UTAH OIL AND GAS CONSERVATION COMMISSION

WELL NO. BRYSON CANYON UNIT # 3

API 43-019-11305

September 15, 1960

WELL LOCATION

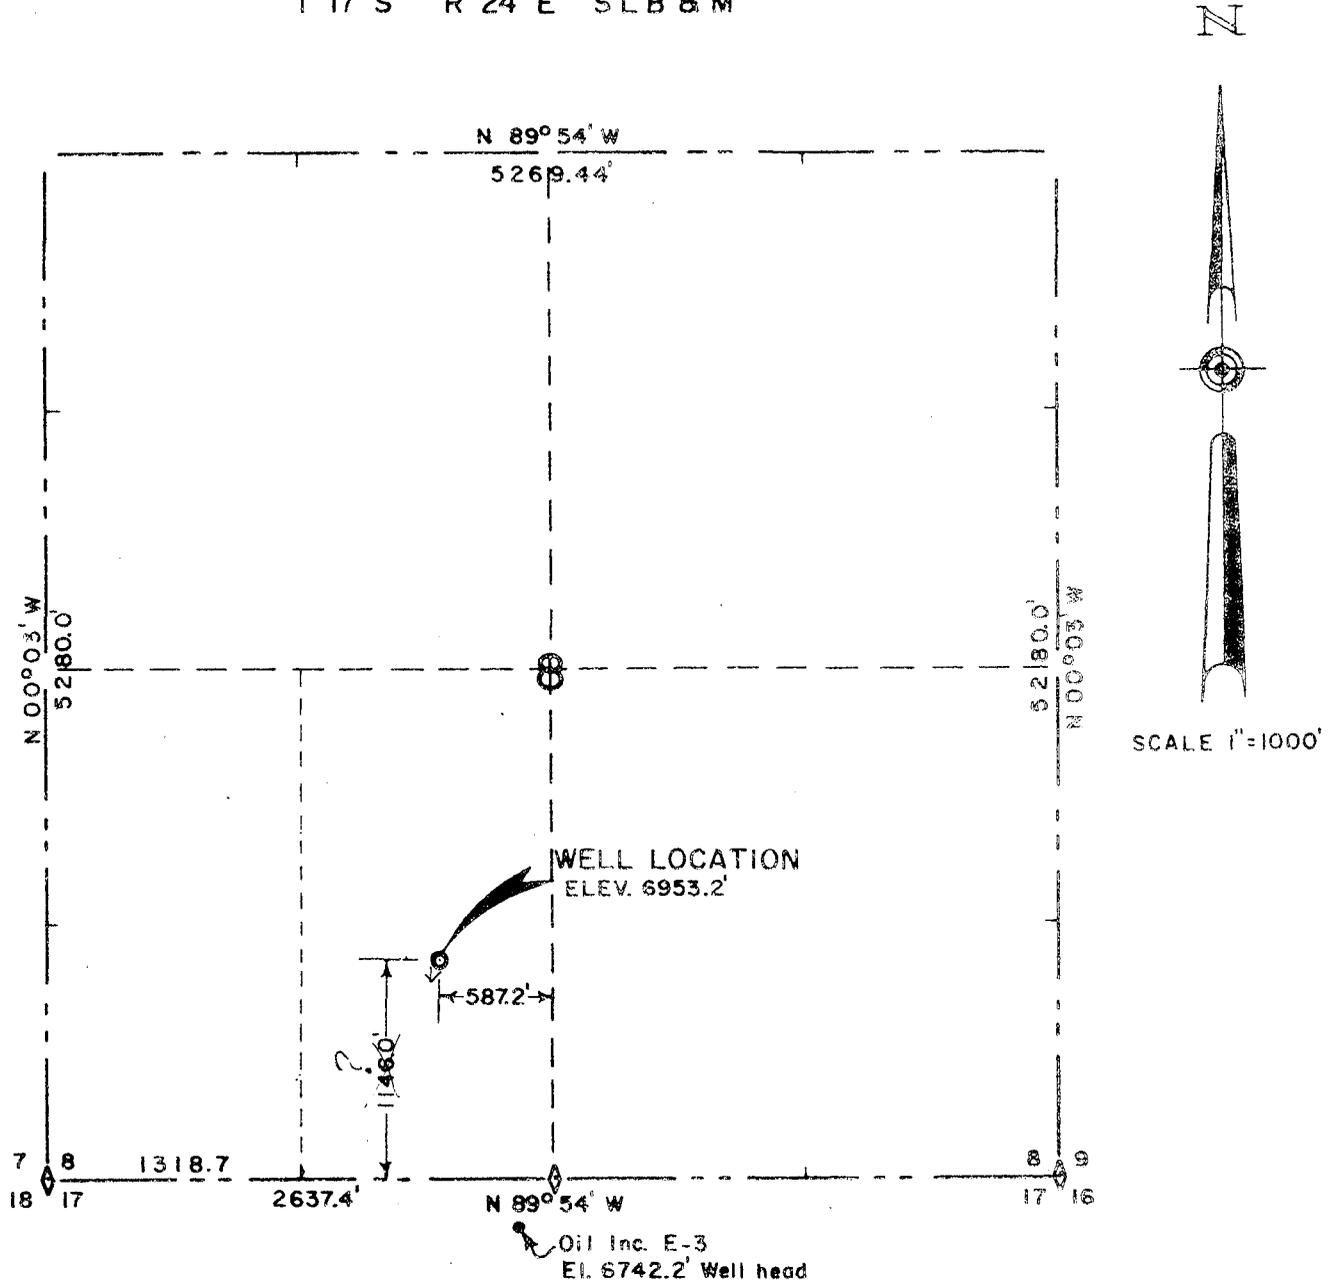
This is to acknowledge receipt of your notice of intention to drill Well No. Bryson Canyon Unit #3, which is to be located 1146 feet from the south line and 2050.2 feet from the west line of Section 8, Township 17 South, Range 24 East, S1M, Westwater Field, Grand County, Utah.

The proposed location of this well does not comply with Rule C-3 (b), General Rules and Regulations and Rules of Practice and Procedure, Utah Oil and Gas Conservation Commission, nor has information been furnished for an unorthodox location as required by Rule C-3 (c) of said rules and regulations.

Before approval can be given for drilling this well, it will be necessary for you to file a new notice of intention to drill in compliance with Rule C-3 (b), or if an unorthodox location is necessary, a request for such spacing must be made as required by Rule C-3 (c).
